CITY OF RIVERSIDE	
PUBLIC WORKS DEPARTMENT	
CONCEPTUAL GRADING PLAN	
SYCAMORE V	
LANCE DRIVE	
BUILDING 2	
Designed by _____	Approved by _____ Date _____
Checked by _____	Public Works Director _____ R.C.E. XXXXX
Designed by _____	Date _____
Checked by _____	Date _____
Sheet 4 of 6 Sheets

Appendix 3: Soils Information

Job No. 07489-3

Subject: Grading Plan Review and Update to Geotechnical Investigation
Proposed Industrial Development - Sycamore V
Lance and Sierra Drives
Riverside, California

ENCLOSURE
1

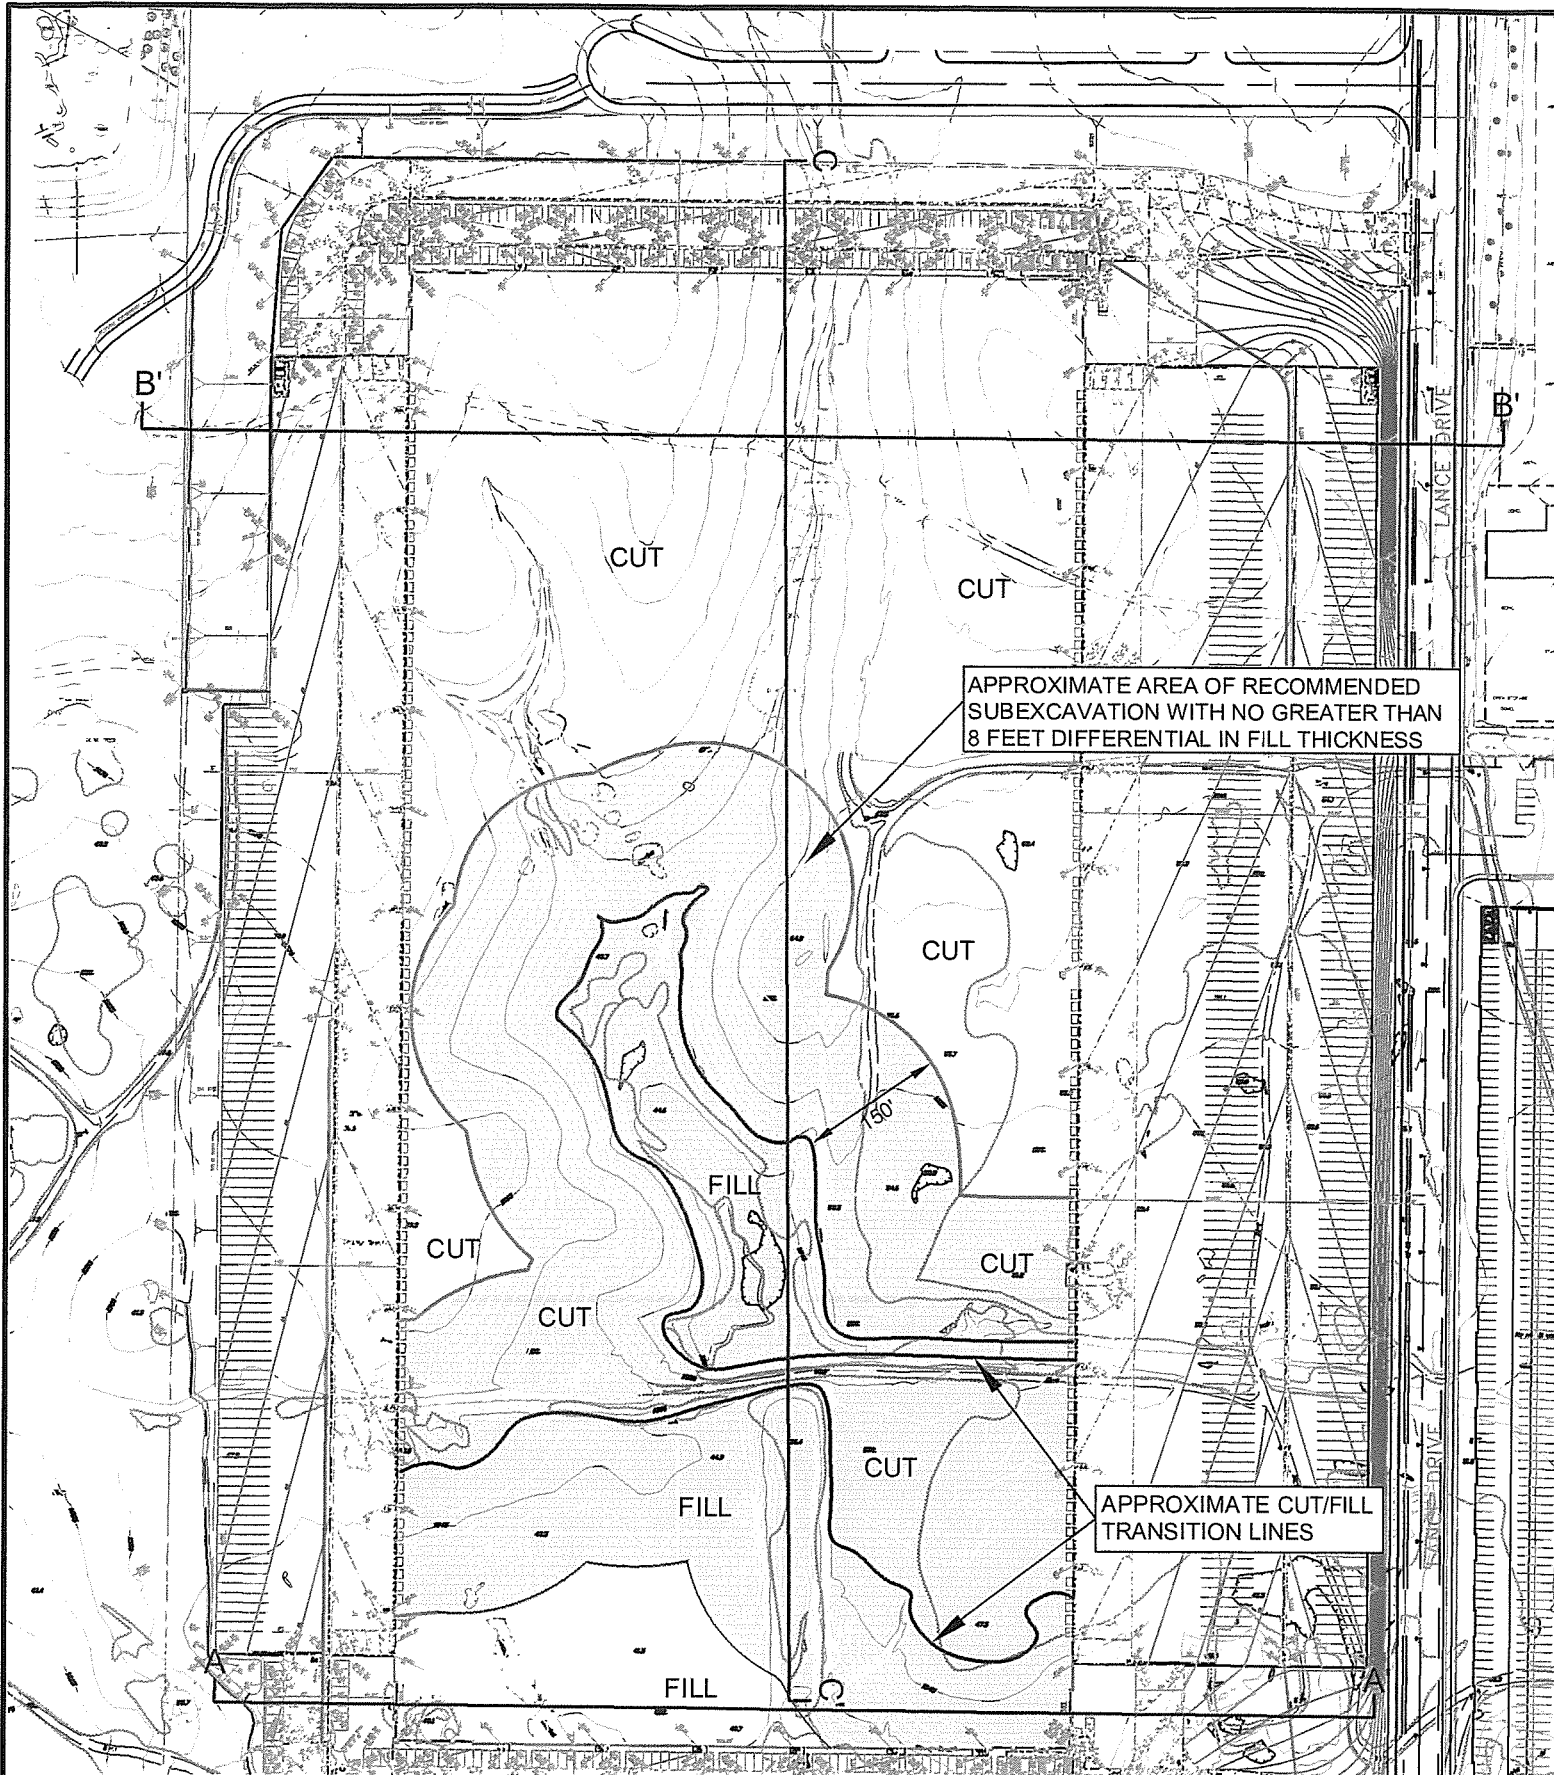
16 feet, when alluvial/colluvial removals are included. Cut-fill transition lines are present in the southern and central portions of the proposed building (Enclosure 1). In order to mitigate the potential for differential settlement across the cut/fill transition area, the pad area including areas underlain by bedrock, should be subexcavated to provide no greater than 8 feet difference in the fill mat thickness within 150 feet of the cut/fill transition line. The 150-foot distance from the transition line is also shown on Enclosure 1. The attached draft cross sections illustrate the cut/fill transition, areas of fill, bedrock cut areas, and potential fill depths beneath footings in rock areas. Our geotechnical investigation recommended a minimum fill thickness of 18 inches beneath all structure footings.

A Proposed Building A'

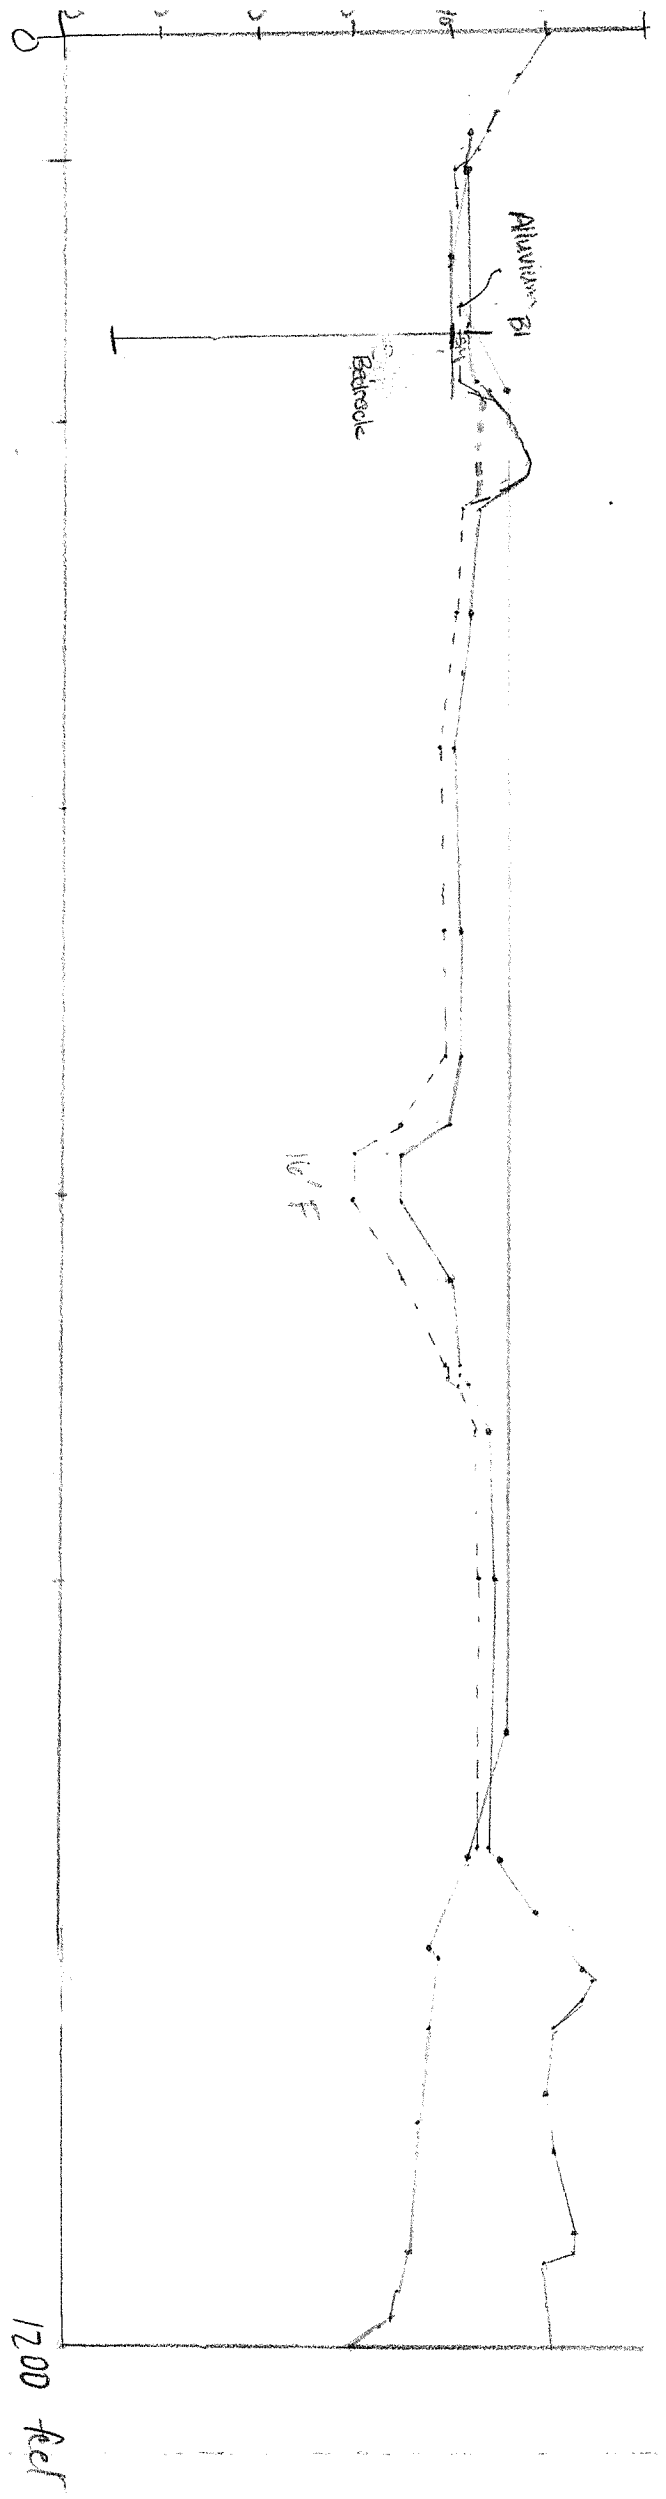
Due to the topographic relief across the site and the varying depth of bedrock, it is not planned for the foundations of the proposed structure to bear entirely in undisturbed bedrock. Grading of the building pad area will entail maximum cuts on the order of 15 to 18 feet and maximum fills on the order of 12 to
